Proposed Development of the Dog on the Tuckerbox Site

Responses to RFI

11 April 2024

Cootamundra-Gundagai Regional Council

Figure 1 *Proposed vehicle access arrangement*

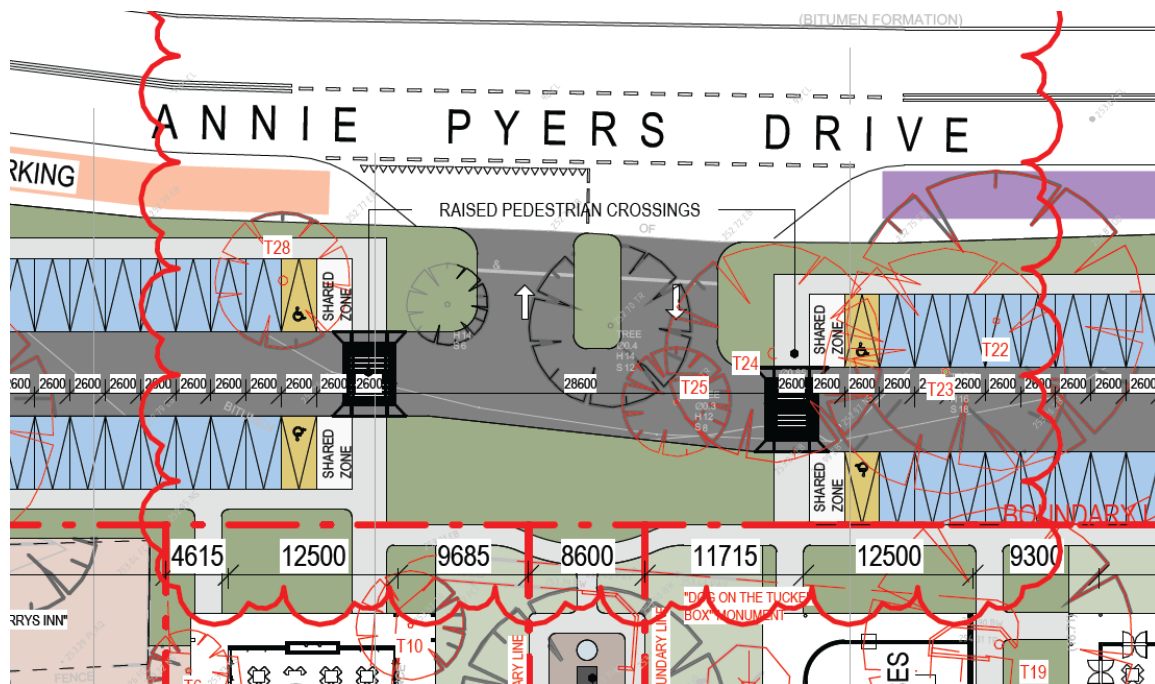
In response to feedback from Council the vehicle access arrangement has been revised to provide for a more conventional 'T-Junction' arrangement as indicated in Figure 1 below. The previous u-shaped roundabout formation has been removed in response to Council's concerns this previous arrangement may have led to driver confusion. The revised access arrangement also responds to a comment from Council's engineer in relation to the vehicle swept paths traversing over an island at the entry point to the site.

The car parking configuration adjacent to the pedestrian crossings have been amended in response to concerns raised by Council. Vehicles entering or exiting parking spaces will not longer be required to reverse across the pedestrian crossings, with a 'shared zone' next to the disabled parking bays now provided immediately adjacent to the pedestrian crossings. This is indicated in Figure 1 on the previous page of this document.

Figure 1 SIDRA layout – northern access point

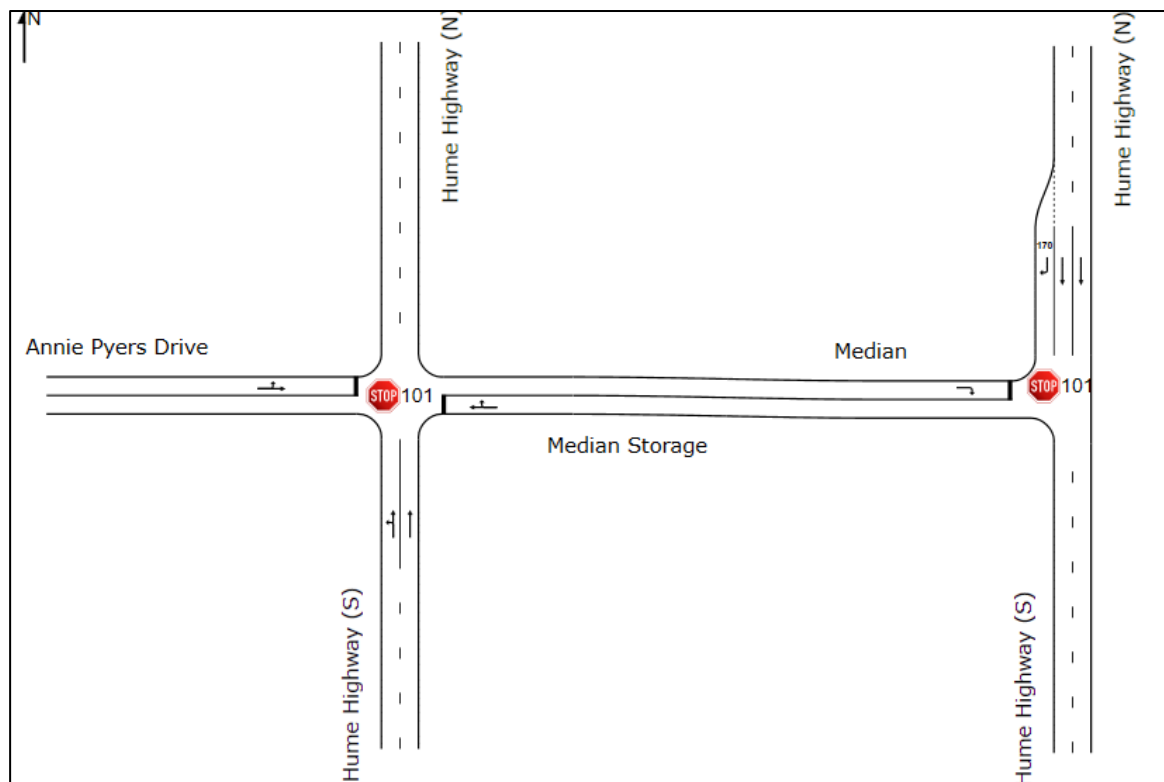
SIDRA layouts were developed to reflect existing site conditions, refer to figures below:
